ADDENDUM NO. 1

TO: PLANS AND SPECIFICATIONS FOR STATE OF MISSOURI

**Renovate Lobby and Restrooms 1st and 2nd Floor
Howerton State office Building
Jefferson City, Missouri
PROJECT NO.: O2339-01**

A-105

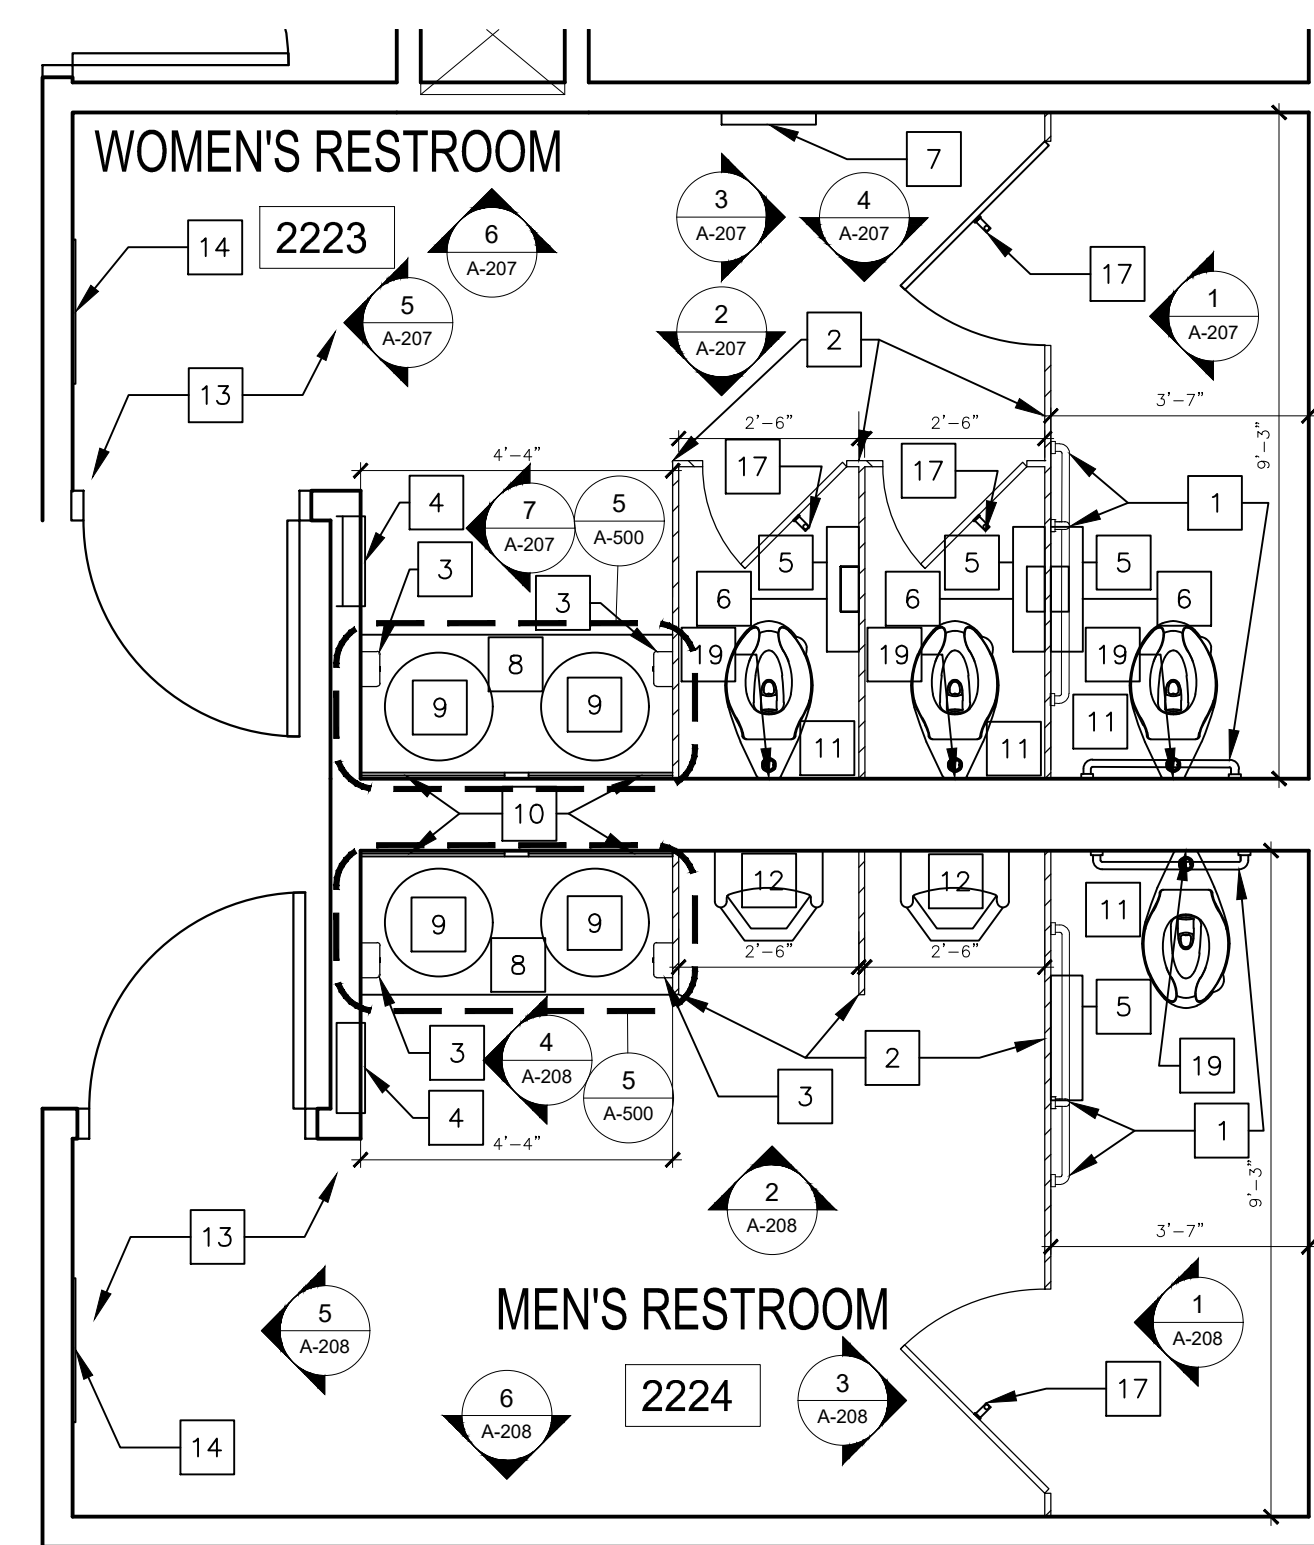
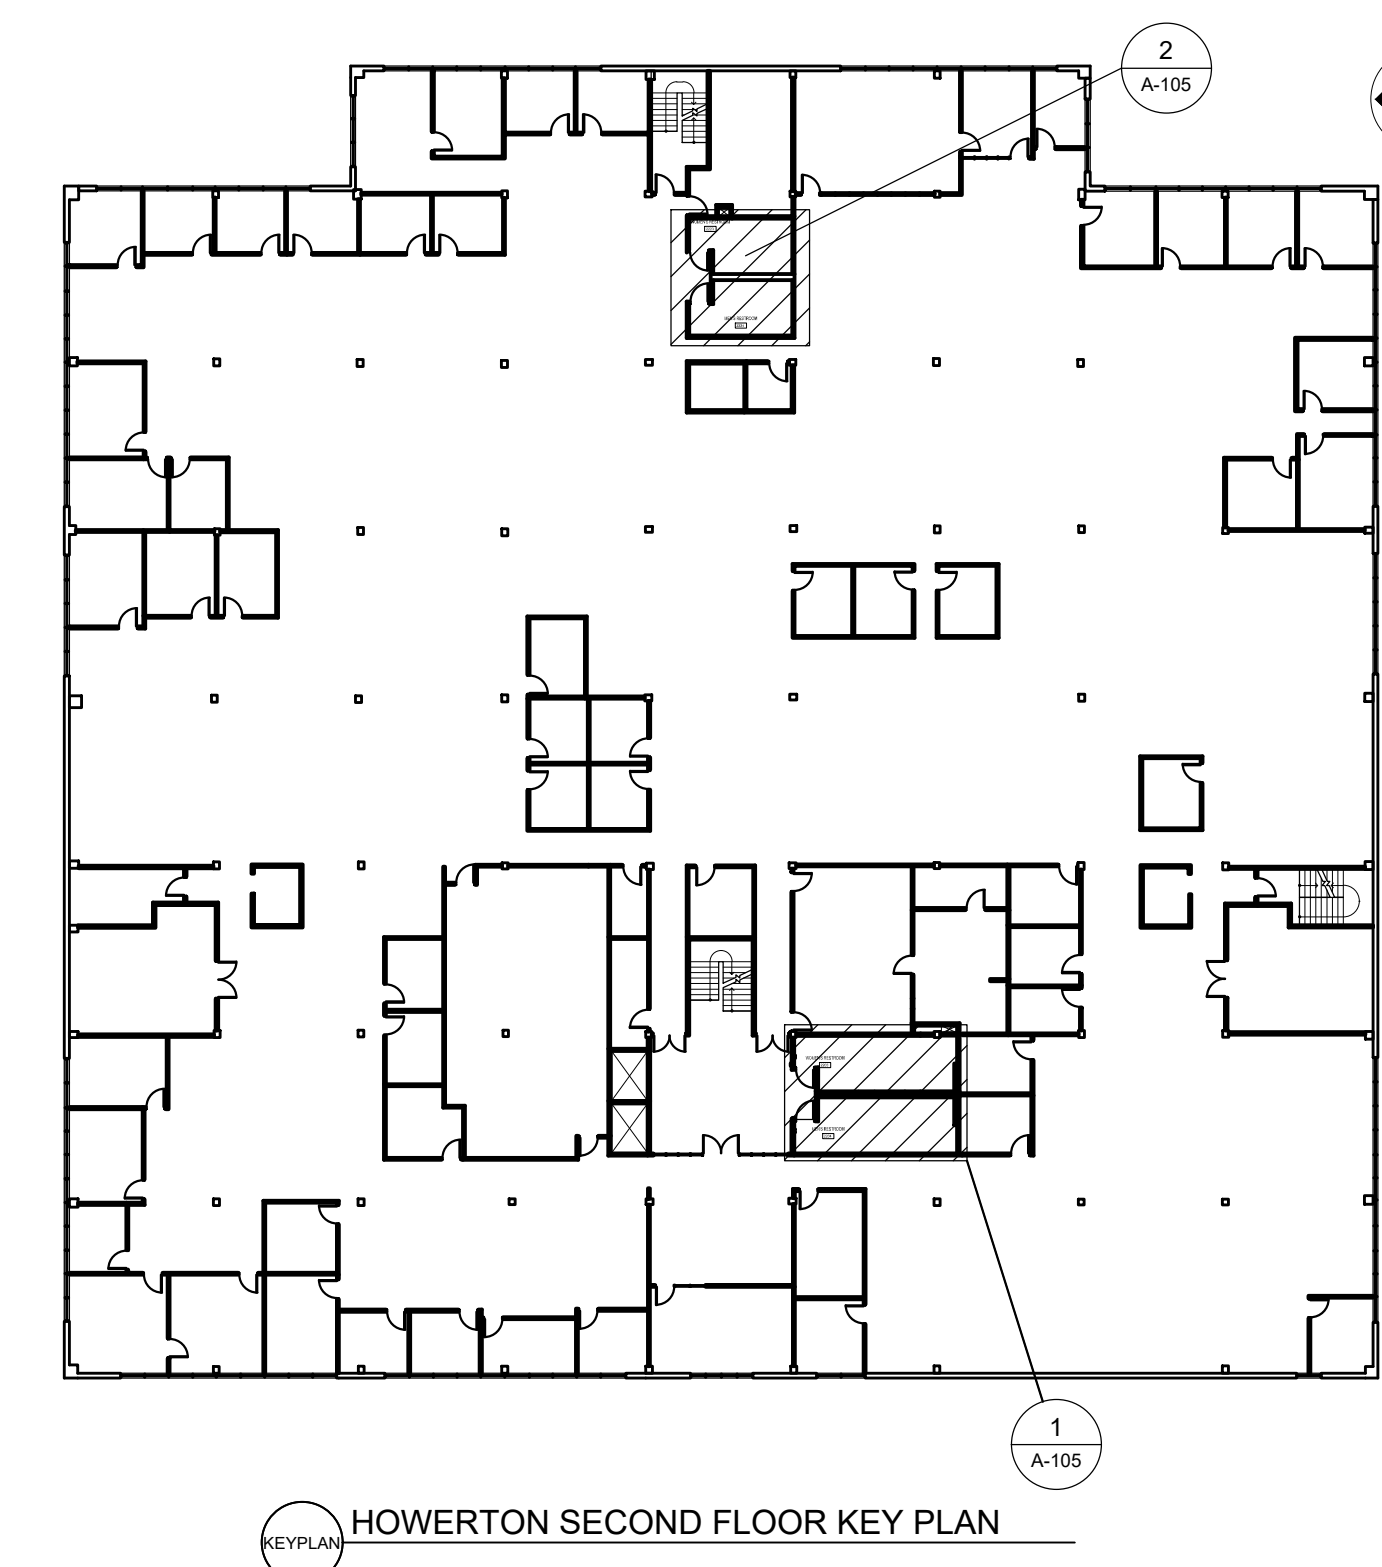
A-105

1. Restroom Fixture Schedule: Quantity changes per mark.
 - GB-1 Quantity changed from 2 to 4.
 - GB-2 Quantity changed from 2 to 4.
 - GB-3 Quantity changed from 2 to 4.
 - LAV-1 Quantity changed from 6 to 10.
 - TA-1 Quantity changed from 8 to 11.
 - TA-2 Quantity changed from 6 to 8.
 - TA-3 Quantity changed from 4 to 7.
 - TA-5 Quantity changed from 4 to 8.
 - TA-6 Quantity changed from 4 to 6.
 - TA-7 Quantity changed from 8 to 11.
 - TA-8 Quantity changed from 6 to 10.
 - TA-9 Quantity changed from 2 to 4.
 - TA-10 Quantity changed from 6 to 10.
 - WC-1 Quantity changed from 8 to 11.
 - WC-2 Quantity changed from 8 to 11.
 - UR-1 Quantity changed from 4 to 5.
 - UR-2 Quantity changed from 4 to 5.
2. Room Finish Schedule: B-1 color changed to Fudge 167.
